**RE: Santa Fe Granite
Grading and Drainage Plan
Engineer's Stamp Date: 05/14/19
Hydrology File: B18D025**

Based upon the information provided in your submittal received 05/14/2019, the Grading & Drainage Plan **is not** approved for Building Permit and Grading Permit. The following comments need to be addressed for approval of the above referenced project:

ENGINEER'S SEAL  5/14/19	SANTA FE GRANITE 5610 VENICE GRADING AND DRAINAGE PLAN	DRAWN BY WCWJ
		DATE 5-09-19
 1806 CENTRAL AVENUE SE SUITE 201 ALBUQUERQUE, NM 87106 (505) 872-0999		SHEET #
		JOB # 2109038

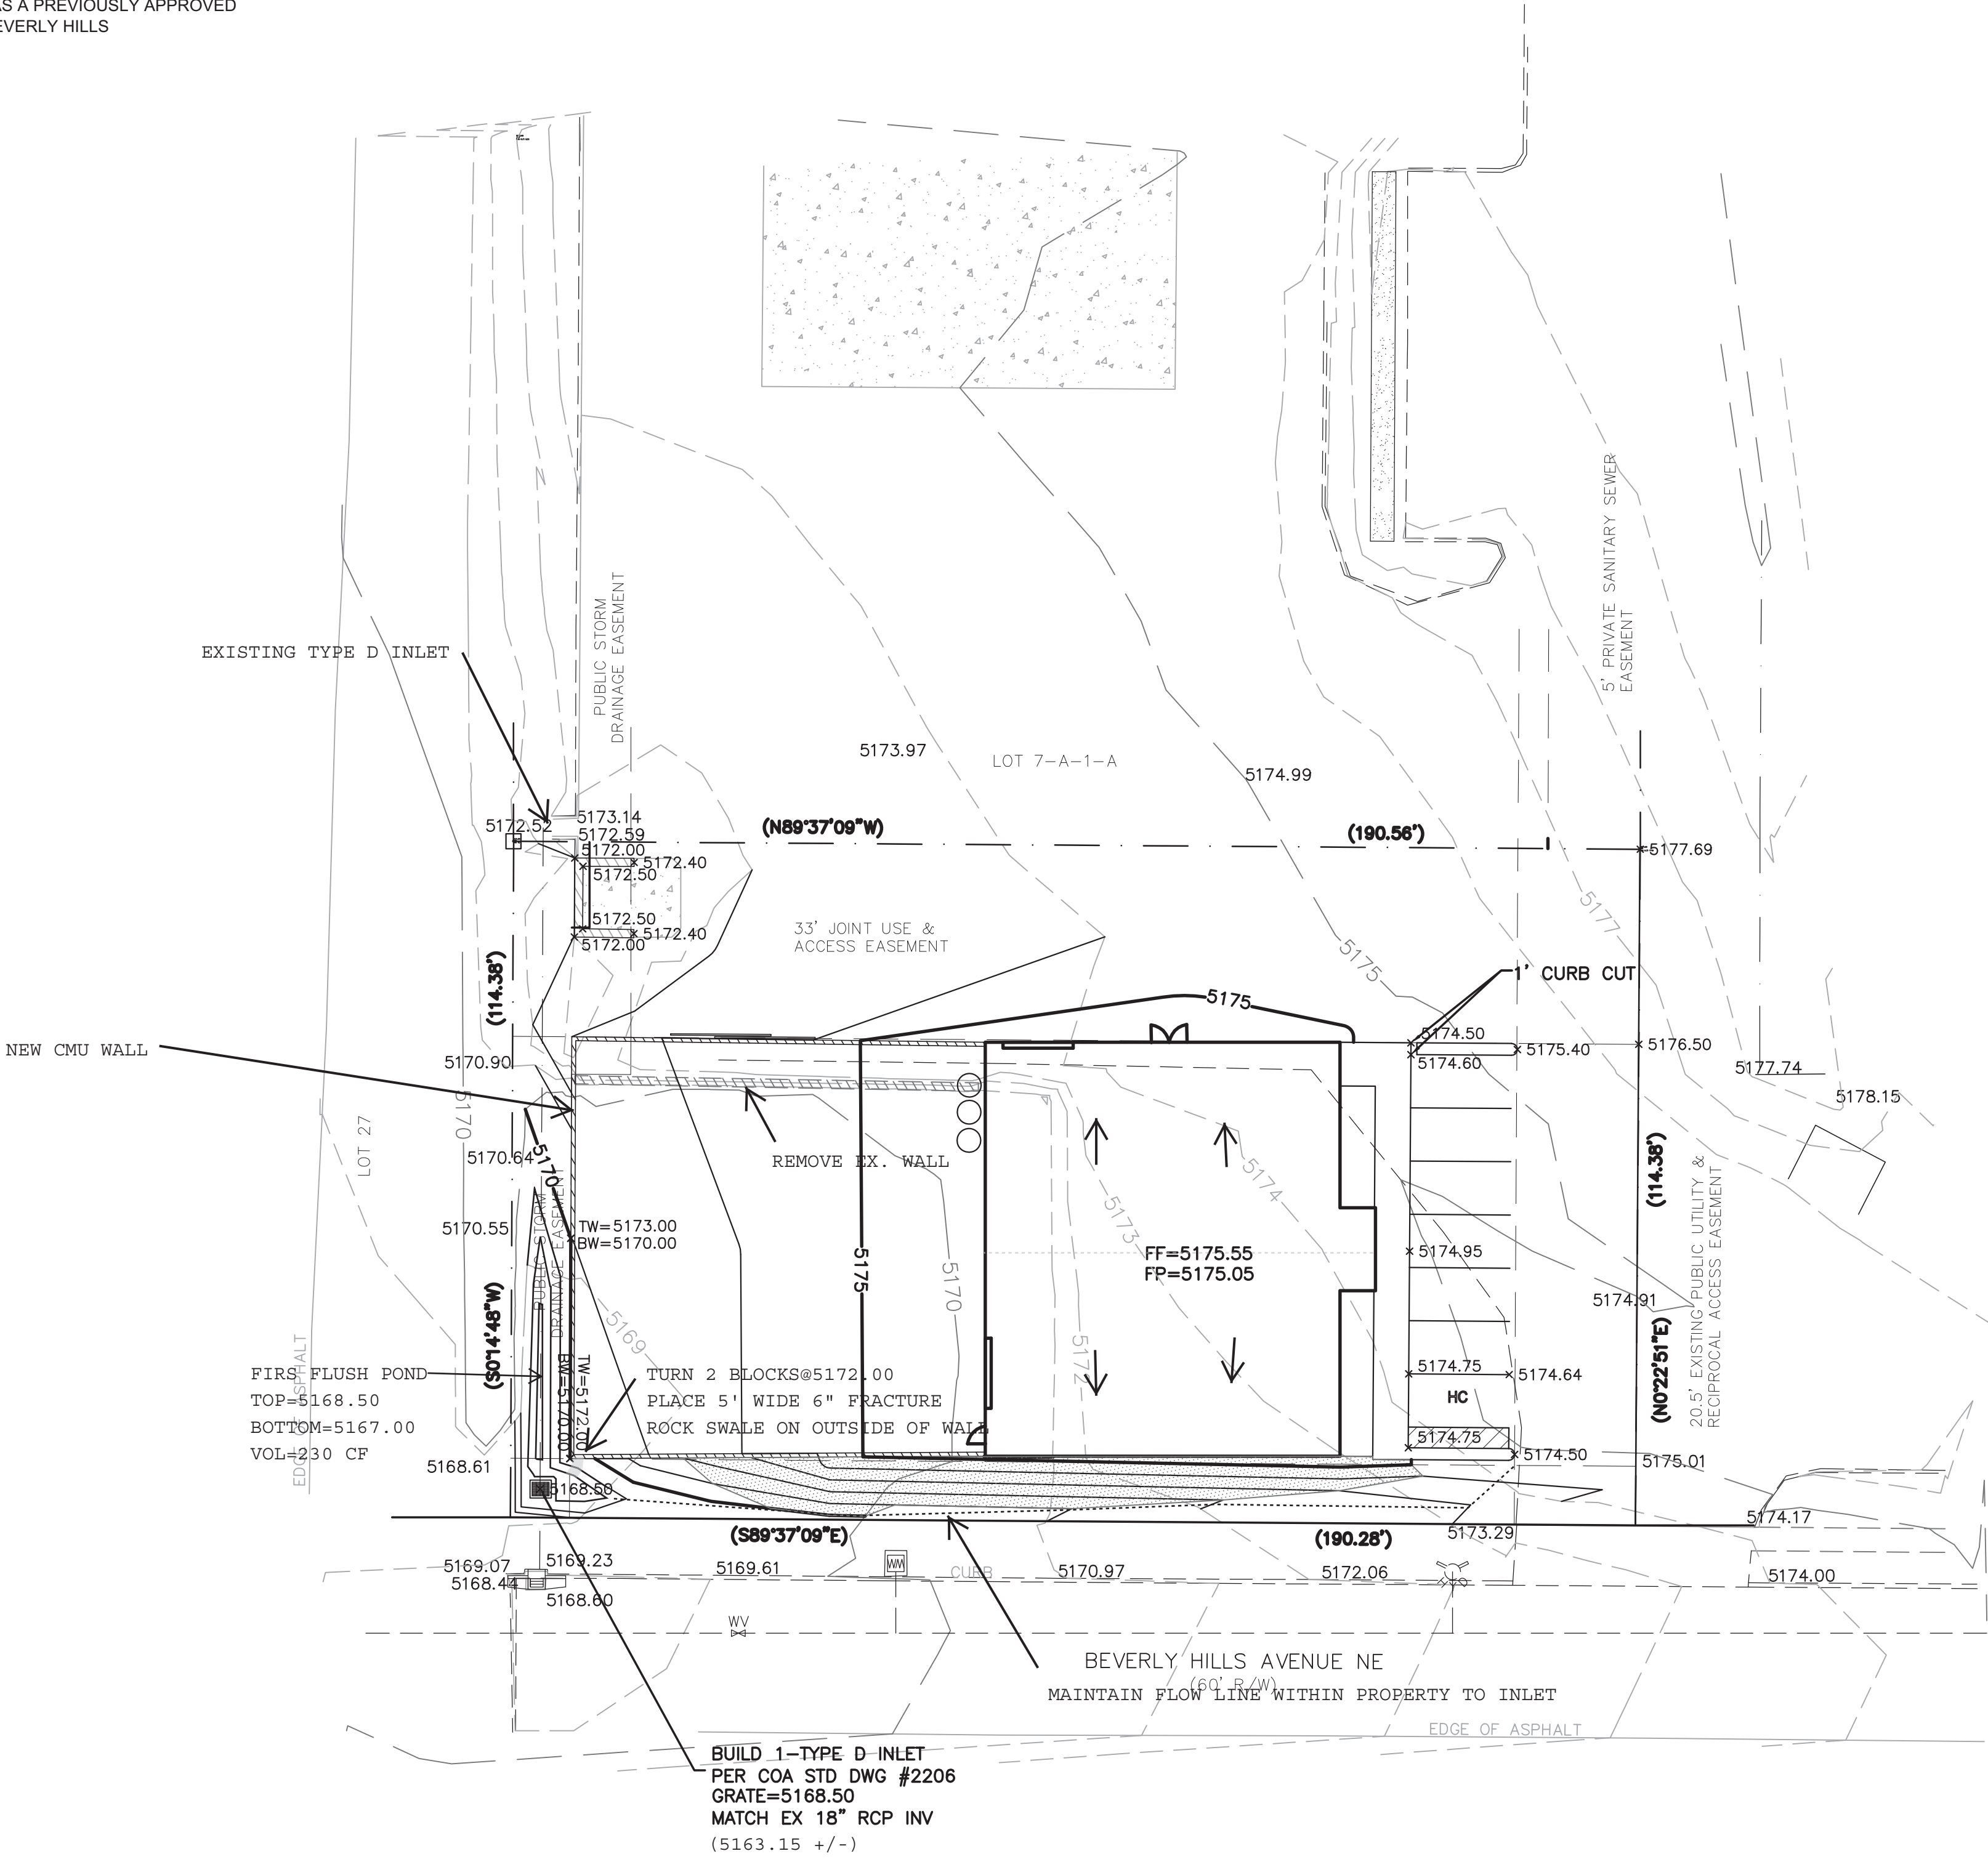
1. Please provide the benchmark information for the survey contour information provided.
2. Please label the existing 18-in storm pipe within the public drainage easement.

3. Please provide a cross section on the west side of the property line through the storm water quality pond and CMU wall. Please show that the footer for the wall does not encroach the existing public drainage easement.

4. The turn blocks needs to be at least four (4) inches above the proposed grade to avoid clogging.
5. Please check with Transportation, the sidewalk along Beverly Hills Ave needs to be built with this project. Also an ADA ramp may be needed at the drive. Also it appears that the parking is right off the drive entrance and may need to be shifted to the west if a drive radius is needed. If these items are needed, this may shift the building and parking over.
